City of Portland, Maine – Building or Use Permit Application 389 Congress Street, 04101, Tel: (207) 874-8703, FAX: 874-8716

RE: 940 Congress St., Portland, ME., CBL 065-G-003

PROPOSED PIZZA VILLA OUTDOOR DECK

BUILDING PERMIT REPORT

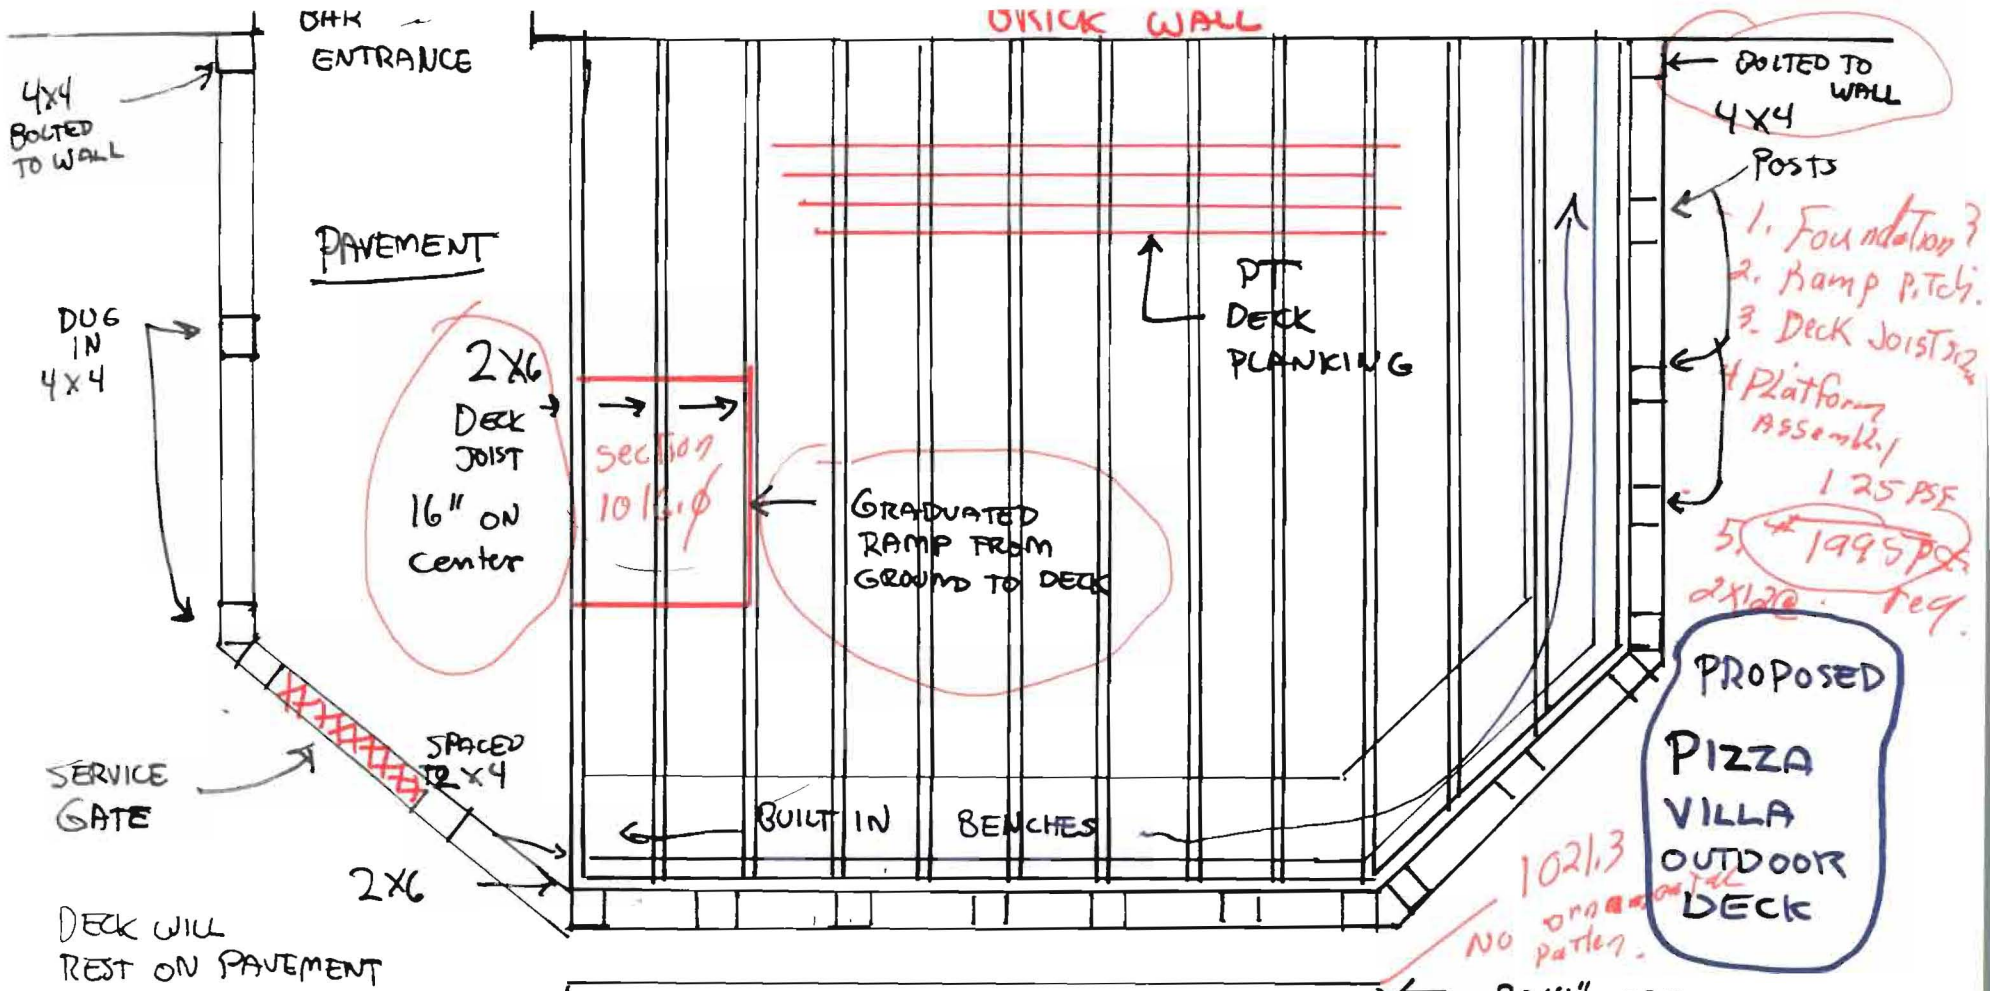
1. The proposed floor joists are 2"x6" spanning 12'. The minimum requirement for a span of 12' carrying a 125 PSF live load (assembly platform) would be 2"x12" at 12" O.C.
2. Your application did not show any type of foundation - 10" piers on footings 4' below grade with anchors between footing, piers and framing would be a minimum requirement.
3. The proposed ramp does not have any details - Section 1016.0 of the building code has these requirements.
4. The proposed guard around the deck does not meet the requirement of Section 1021.0 of the building code (Section 1021.3 opening limitations).

- 1. Foundation?
- 2. Ramp Pitch.
- 3. Deck Joists?
- 4. Platform Assembly
- 1.25 PSF
- 5. ~~1995~~ req.

*6/June/99 Talked with owner and contractor
The 2x6" Joist will be resting the entire length on
The ground - no opening between grade on joists.
All material to be P.T. Wood*

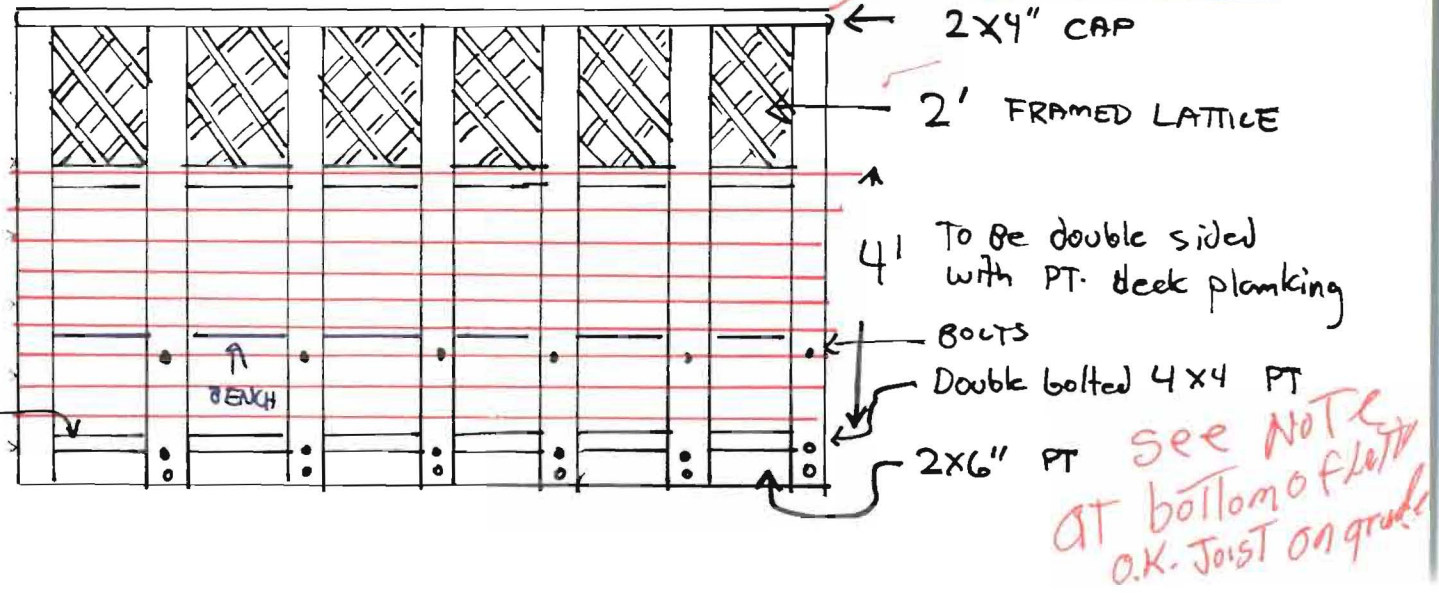
TOTAL DISTANCE OF DECK TO PAVEMENT - **6 1/2" (Inches)**

102/1.3
NO DRIP PATTERNS

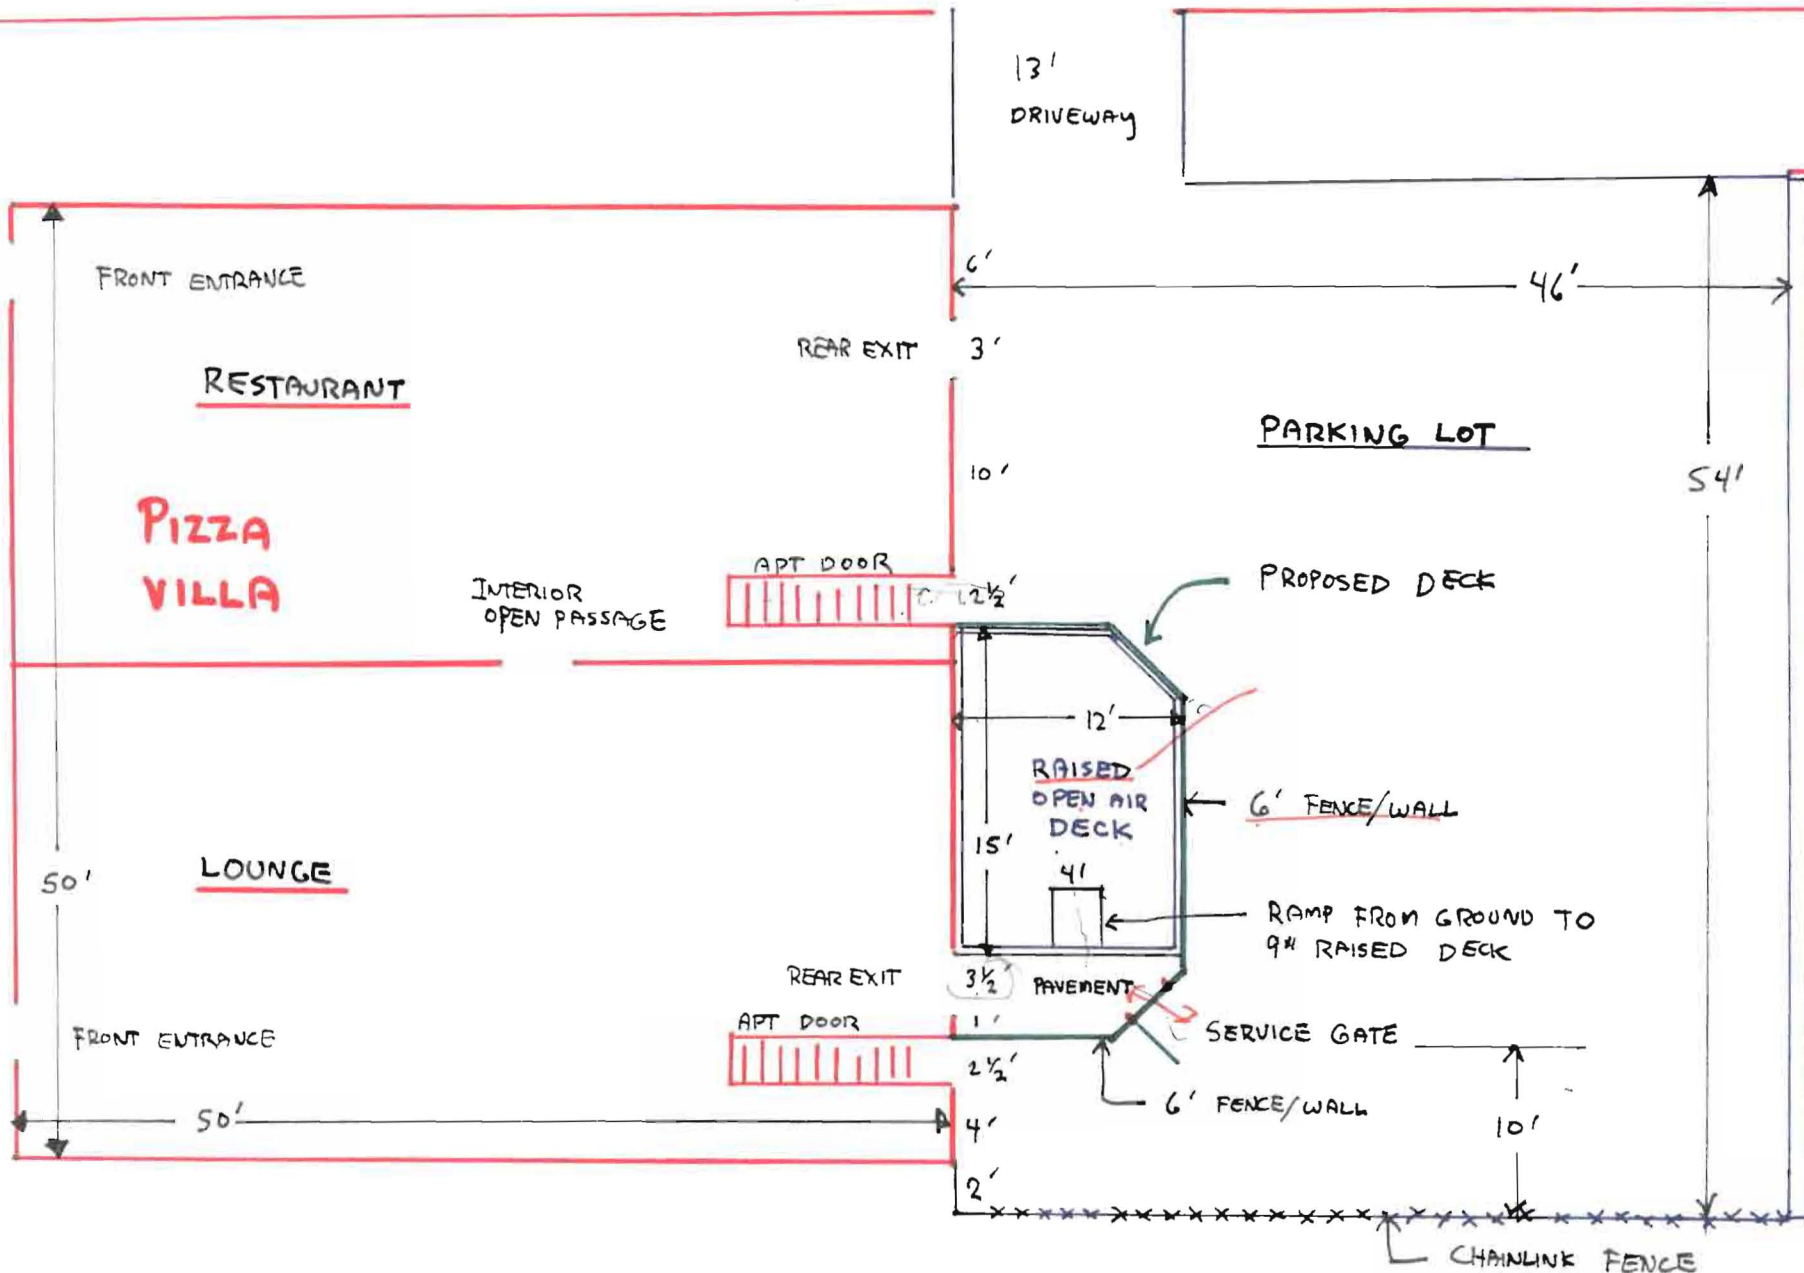
see NOTE AT bottom of floor O.K. JOIST ON grade

PROPOSED DECK

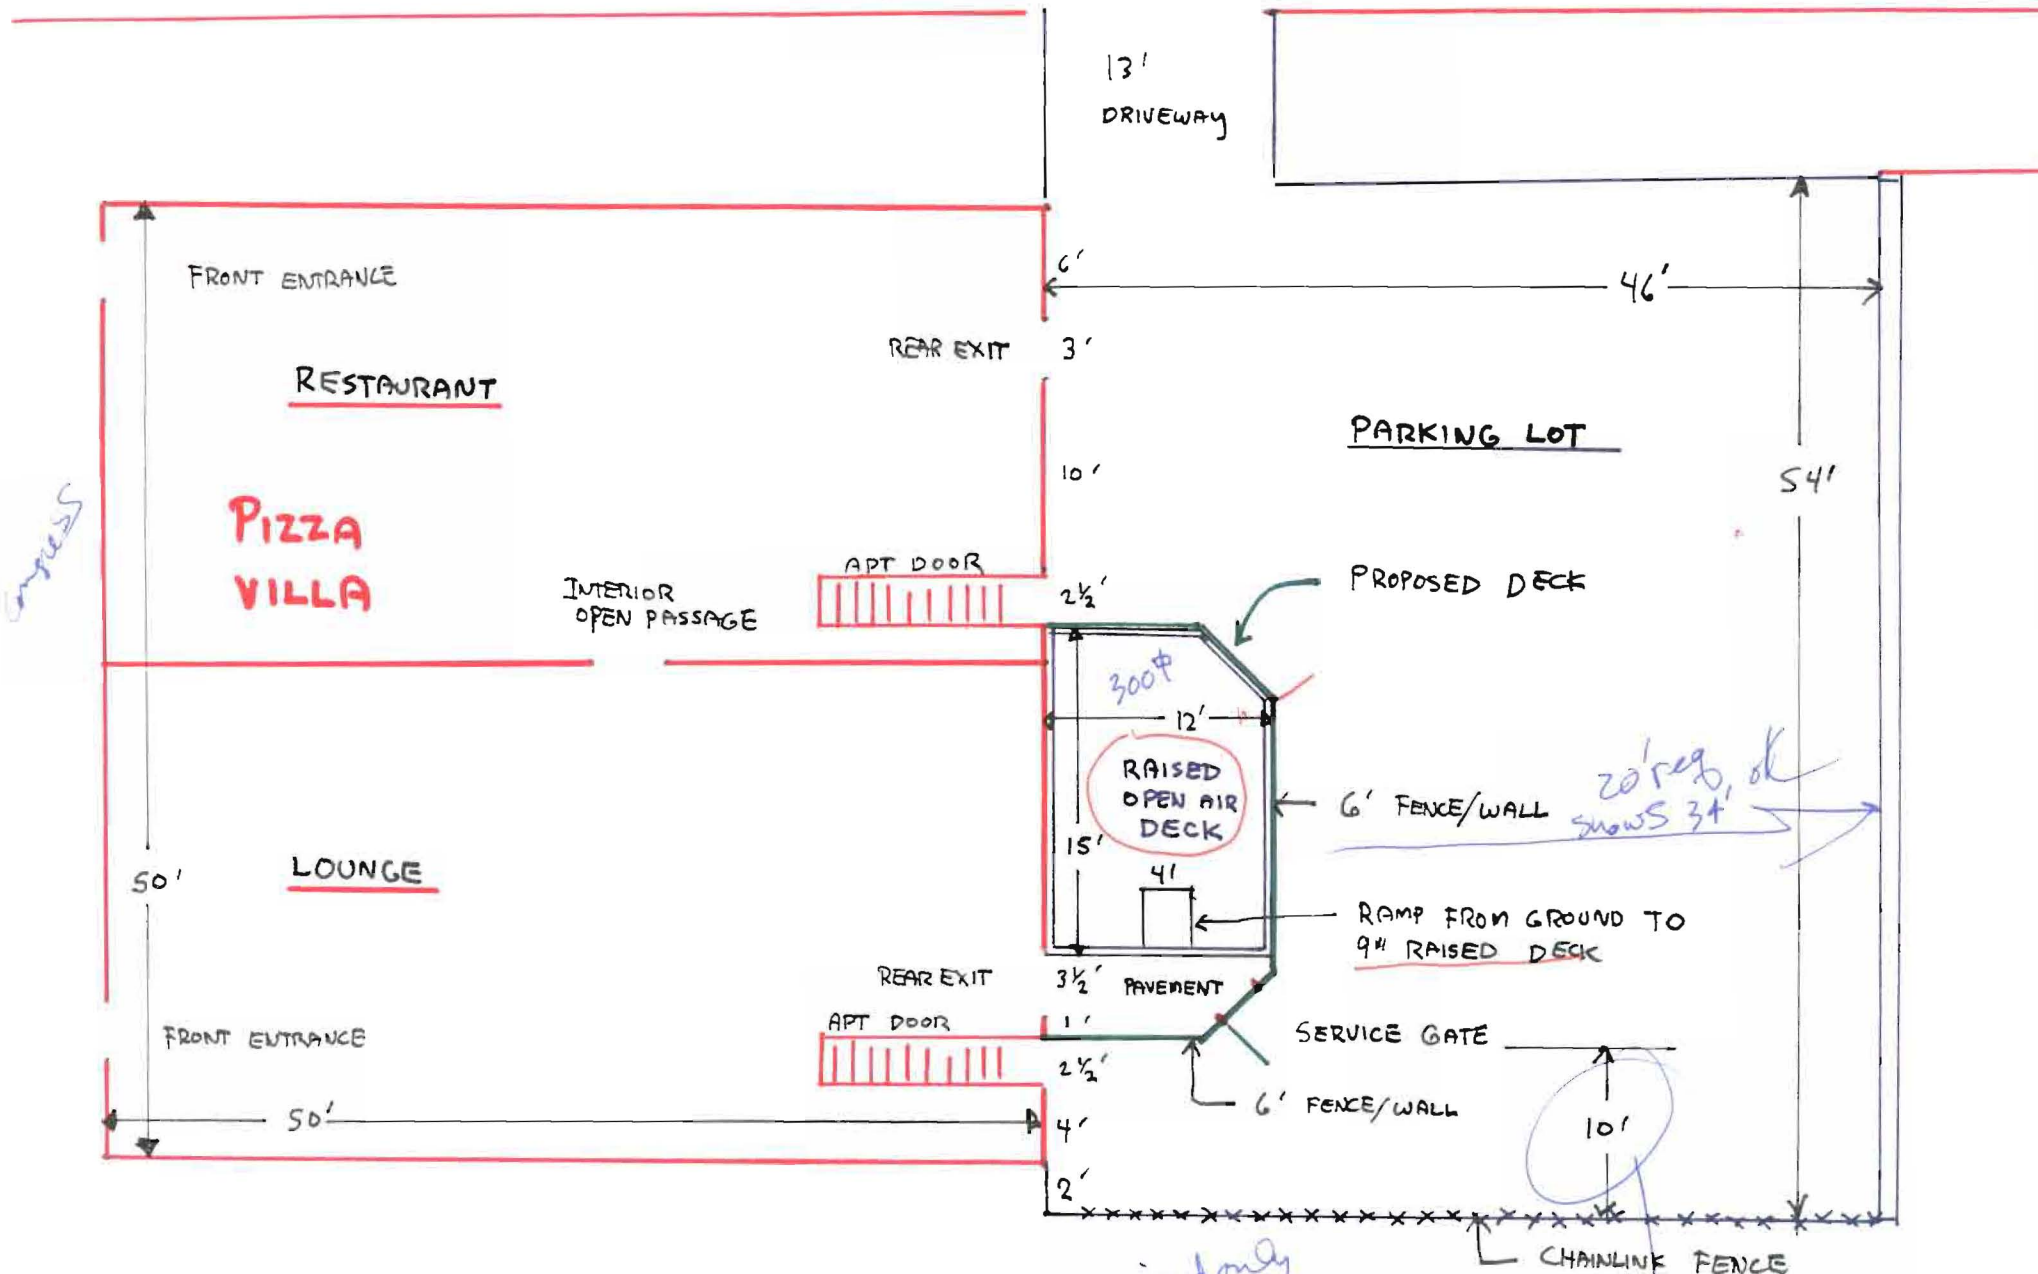
20' req. of
shows 34'

20' from rear required only

not required
